AMENDMENT NO. 1 JUNE 1998
TO
IS 6533 (PART 2) : 1989 CODE OF PRACTICE FOR
DESIGN AND CONSTRUCTION OF STEEL CHIMNEY
PART 2 STRUCTURAL ASPECT

(First Revision)

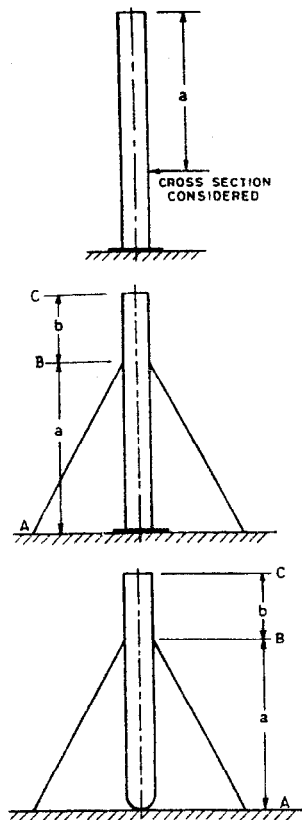
(Page 5, Table 2) — Substitute the following set of figures for the existing:
